**RE: Venice Volleyball Courts
Conceptual Grading & Drainage Plans
Engineer's Stamp Date: 10/05/23
Hydrology File: B18D022**

Based upon the information provided in your submittal received 10/06/2023, the Conceptual Grading & Drainage Plans are preliminary approved for action by the Development Facilitation Team (DFT) on Site Plan for Building Permit.

Date: October 2023
Scale: Horiz: N/A
Vert: N/A
Project No: 9432605
Sheet: C-7

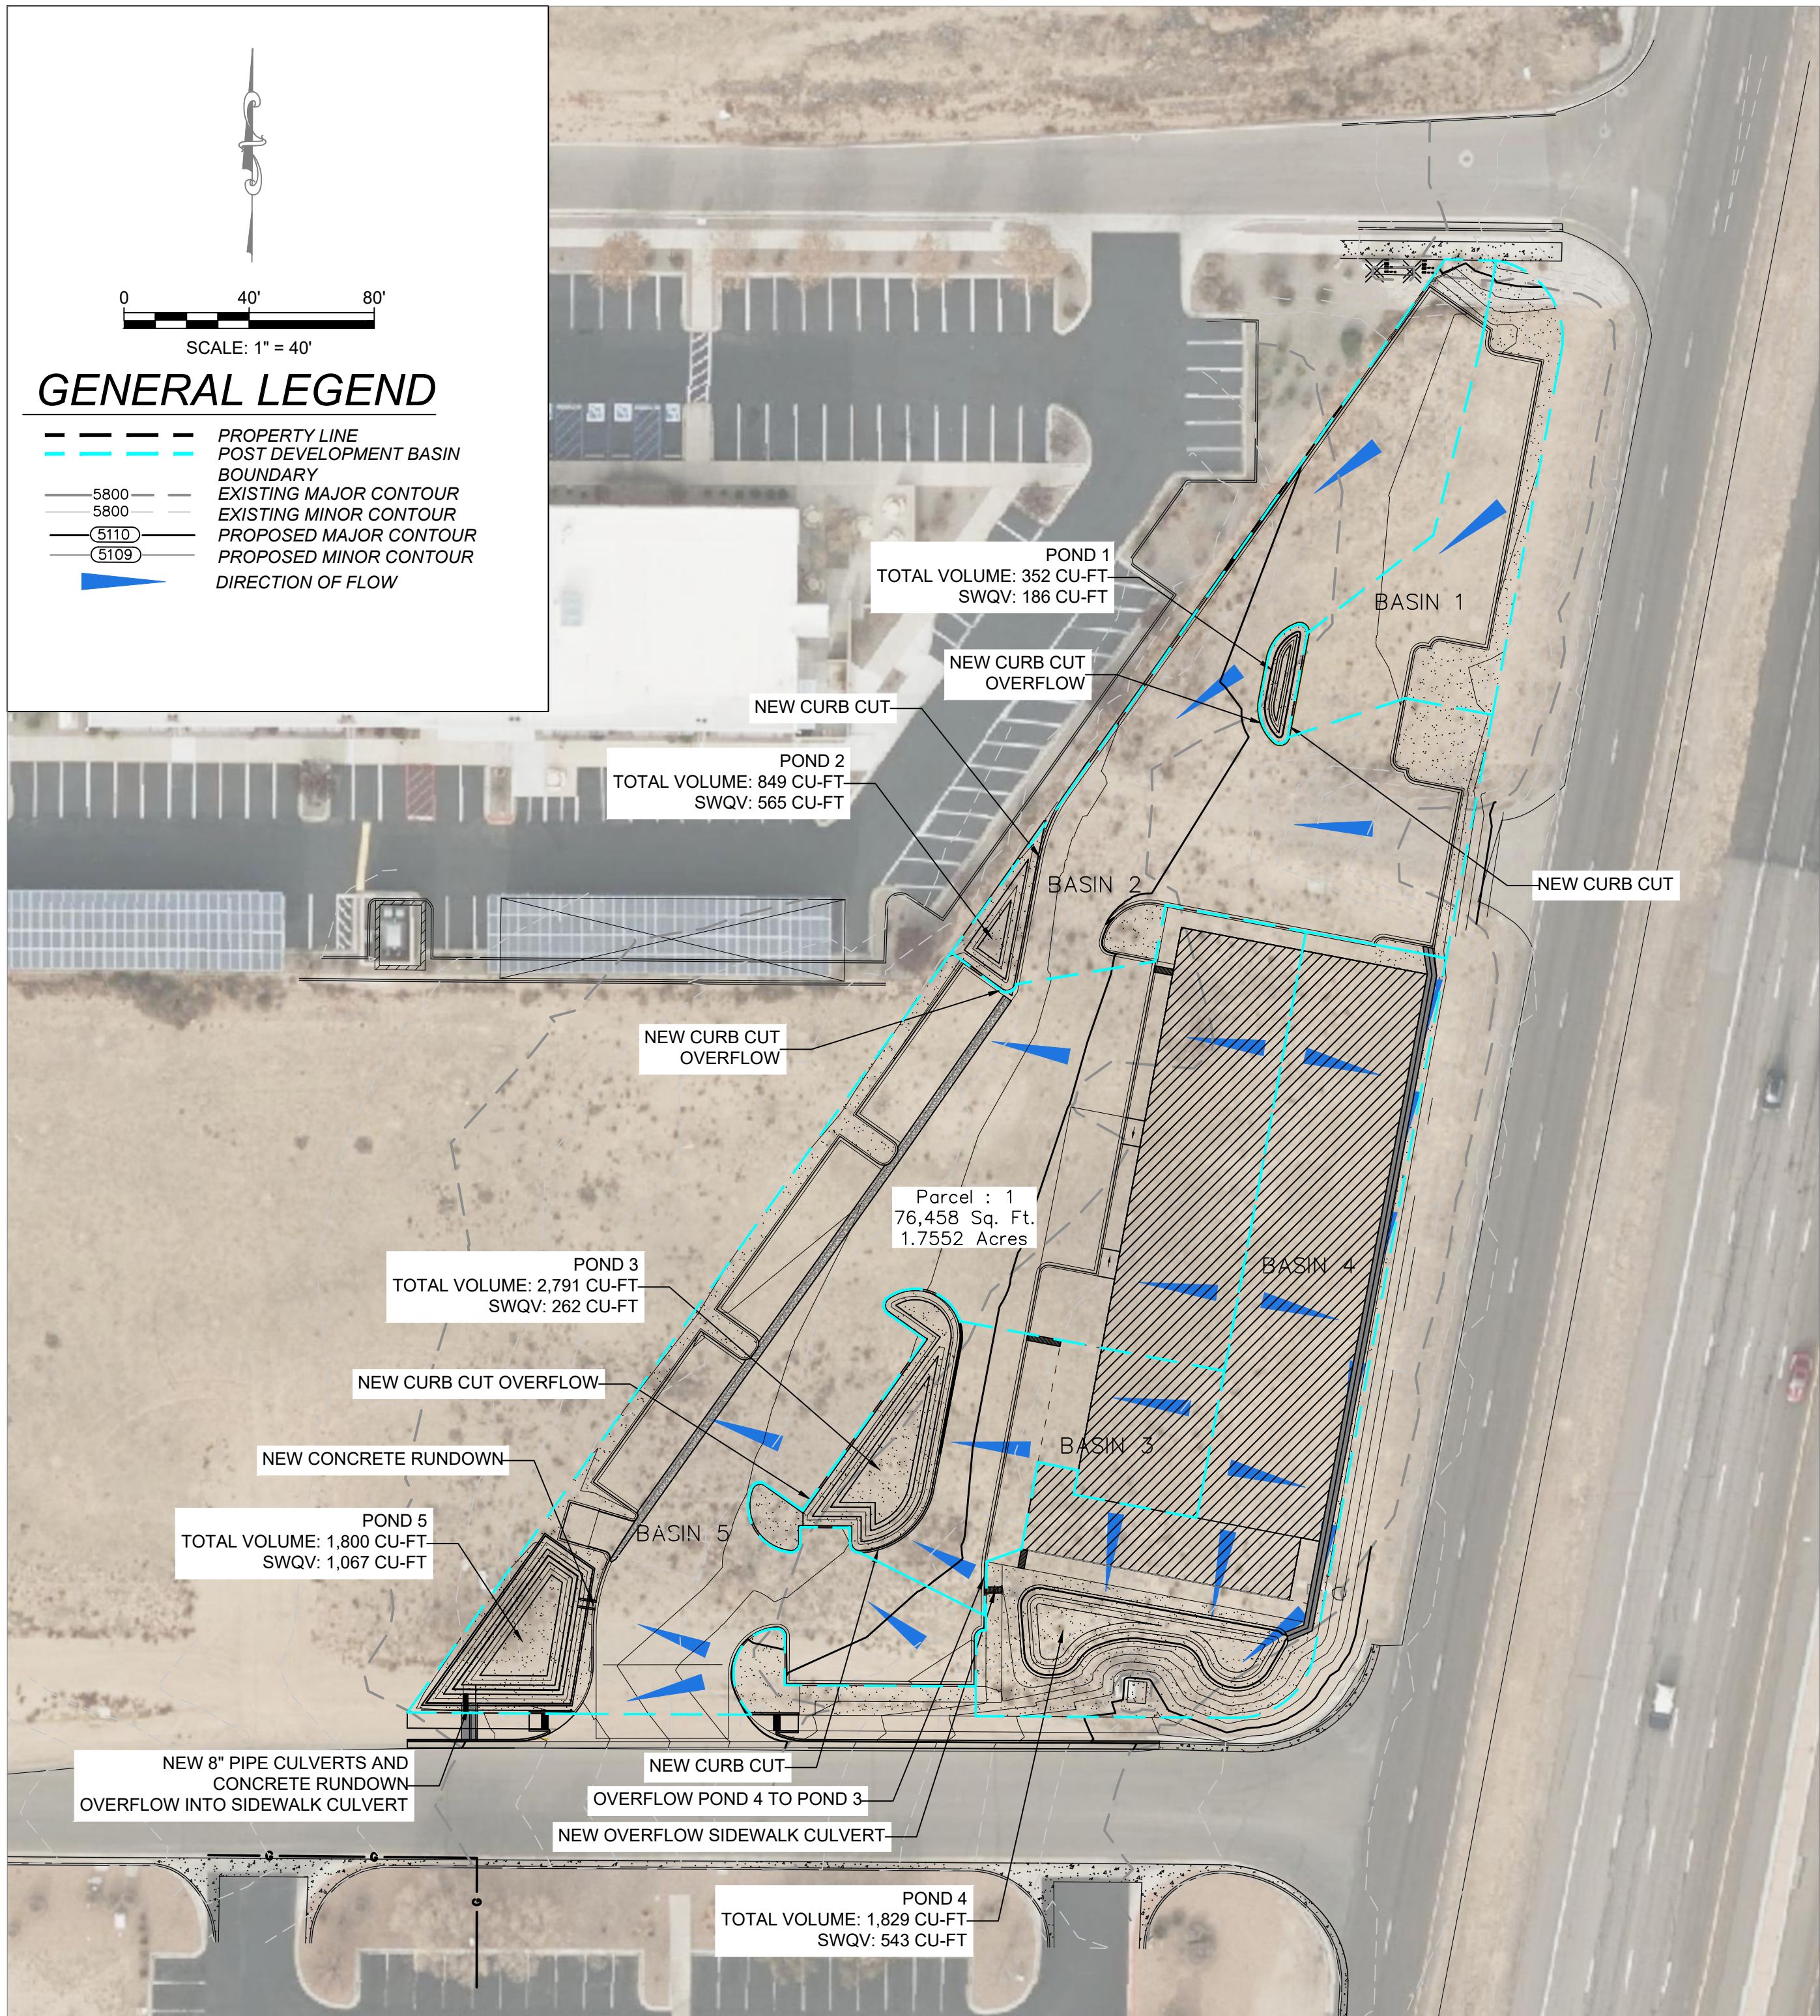
1. Please submit a more detailed Grading & Drainage Plan to Hydrology for review and approval. This digital (.pdf) is emailed to PLNDRS@cabq.gov along with the Drainage Transportation Information Sheet.
2. Please also address the following minor comments:
 - a. This site does have free discharge into Venice. Please revise the site ponds to only handle the required Stormwater Quality volume.
 - b. Please show a rocked swale down Venice and install a beehive inlet and a little bit of 24-in RCP. (Please note that the drawing with the swale and beehive was from the previous development). This work will can be done as a procedure B with an infrastructure list.
